DETAILED ACTION

Art Unit: 2851

FIG. 3

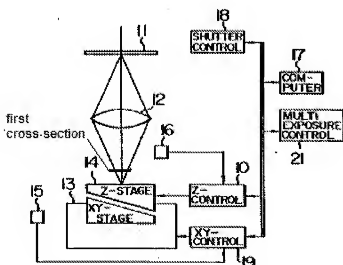
Re claims 5 and 1: Fukuda discloses a system [Fig 3] for recording a pattern 11, comprising:

a controller 17, for determining an illumination scheme [via multi-image using exposure control system 21] in response to the pattern; and

optics [shutter controlled by shutter control system 18], coupled to the controller, for directing, in response to the determination, at least one beam of radiation [C11L62-63: excimer laser] having a first cross-section [see line in Drawing 1] towards a reversible transmission film 44 so as to allow a portion of said beam to propagate towards a radiation sensitive layer 42, wherein the portion has a second cross-section [see grooves between resist pattern 46 in Fig 8d] that is smaller than the first cross-section.

Drawing 1 Location of first cross-section shown.

Re claims 7 and 3: Fukuda discloses wherein the second cross-section [see Fig 8d] is about half of the first cross-section [see Drawing 1].
